Access Compliance Report

Public Rights-of-Way

(Curb Ramps)

Intersection ID: 15435	Main Street: LATTIMORE_ST	Cross Street: SCOTT_AV	Location: W
ADA ID: E3132485D1C6	Ramp Type: Directional1	Initial Pass/Fail: Fail	Overall Compliance: No
Severity Score: 25			
Codes/Mitigation Info/Possible Solution		Field Measurements/Component Compliance

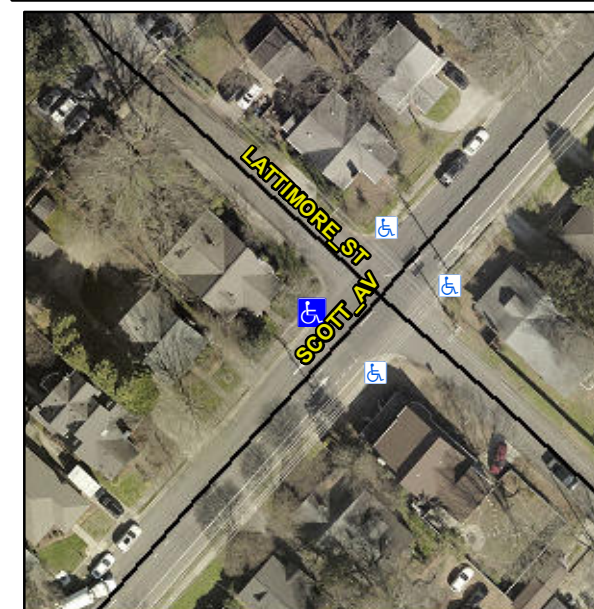
Compliance	Description	Data	Compliance	Description	Data
N/A	Ramp Length (in)	54.0	N/A	Grade Break?	N/A
Yes	Ramp Width (in)	76.0	N/A	Grade Break Slope (%)	0.0
Yes	Ramp Slope (%)	5.6	N/A	Grade Break XSlope (%)	0.0
No	Ramp XSlope (%)	10.2			
N/A	Flare Type LT	N/A	N/A	Flare Type RT	N/A
N/A	Flare Slope LT (%)	N/A	N/A	Flare Slope RT (%)	0.0
N/A	Flare Traversable LT?	N/A	N/A	Flare Traversable RT?	N/A
N/A	Landing Length (in)	0.0	N/A	DWS Provided?	N/A
N/A	Landing Width (in)	0.0	N/A	DWS Contrast?	N/A
N/A	Landing Slope (%)	0.0	N/A	DWS Length (in)	N/A
N/A	Landing X Slope (%)	0.0	N/A	DWS Full Width?	N/A
N/A	Landing Curb? (Y/N)	N/A	N/A	DWS Offset LT (in)	N/A
N/A	Shared Landing?	N/A	N/A	DWS Offset RT (in)	N/A
N/A	Gutter Ponding?	0.0	N/A	Gutter Slope (%)	N/A
N/A	Gutter Lip Ht (in)	0.0	N/A	Gutter X Slope (%)	N/A
N/A	Painted X Walk1?	No		Road Slope (%)	0.9
	X Walk 1 Direction	To NE		Road X Slope (%)	2.8
	X Walk 1 Width (in)	N/A		Clear Space?	N/A

Remove & Replace Entire Ramp.

R304.5.3
